DEVELOPMENT REVIEW COMMITTEE

1. BDS Commercial Site Plan

BDS COMMERCIAL SITE PLAN

FINAL PLAN SET

PHOTOMETRIC PLAN

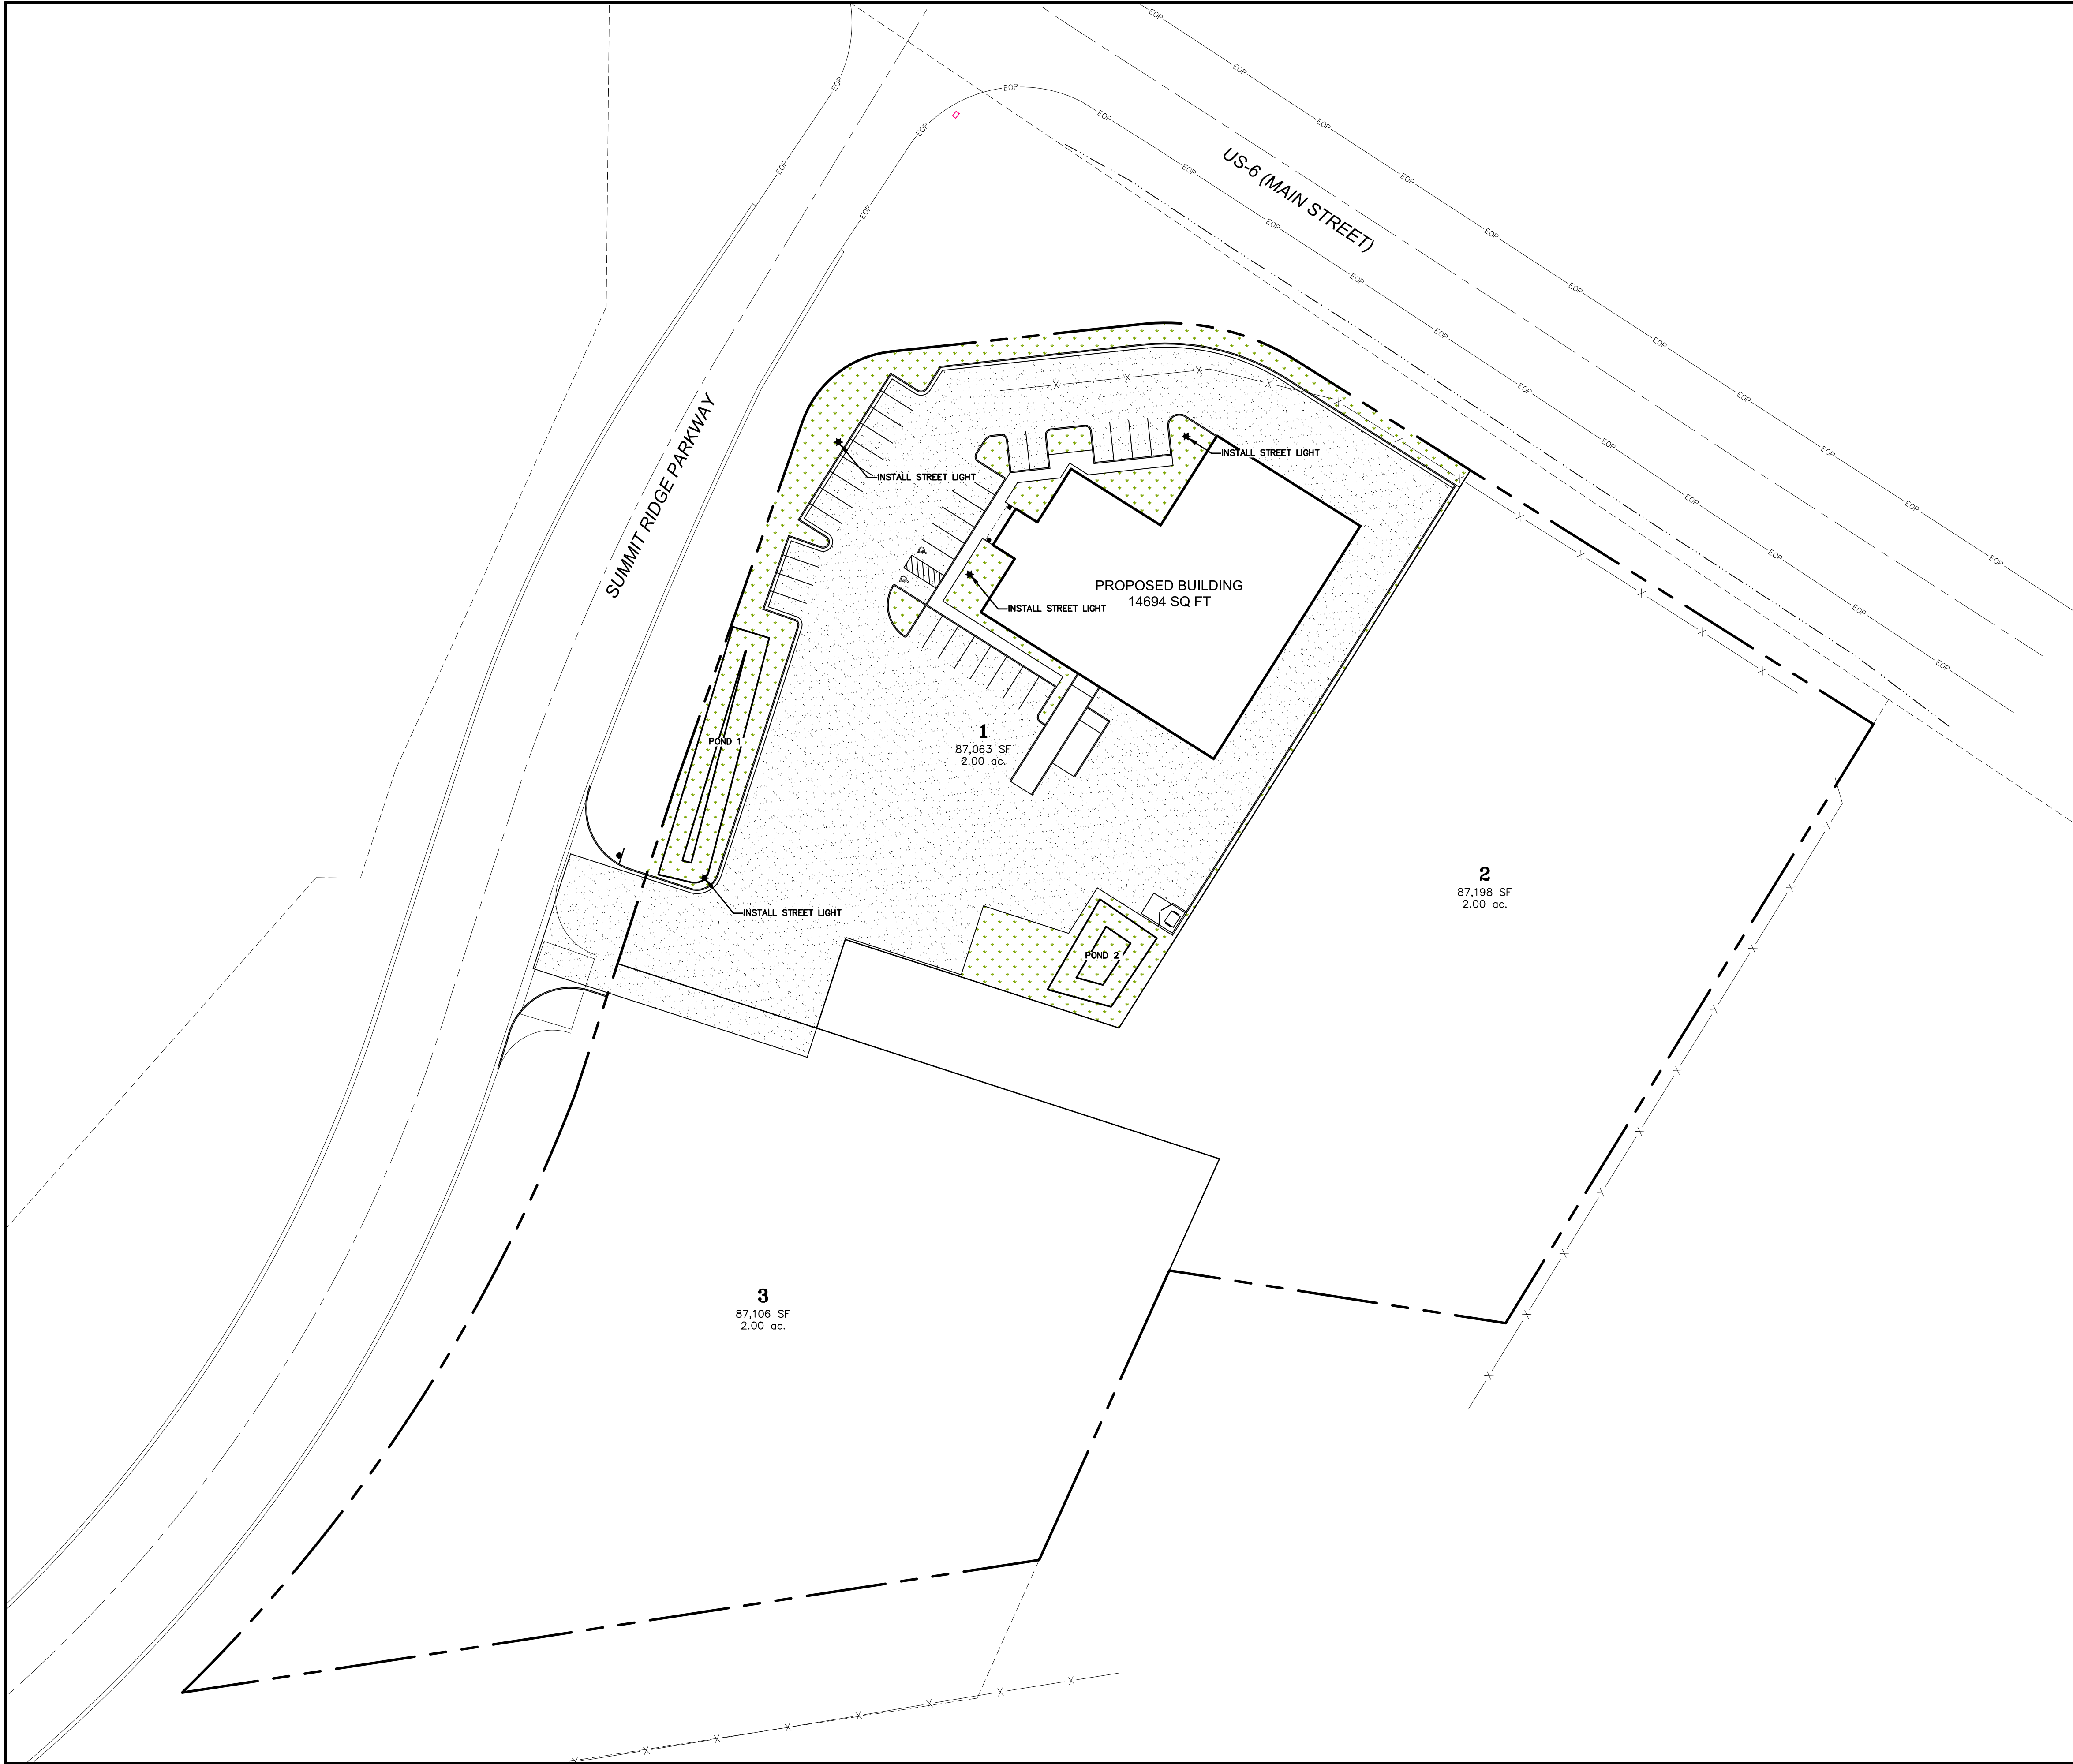
Engineer Lundell and Manager Beagley discussed the requirements for site lighting. The applicant will need to submit a photometric plan for lighting to the City for review. Pedestrian circulation around the building will need to be adjusted to meet the 6-foot requirement in the City Code. Manager Beagley inquired what the applicant's plan is for storm drainage. The applicant indicated that storm drainage is
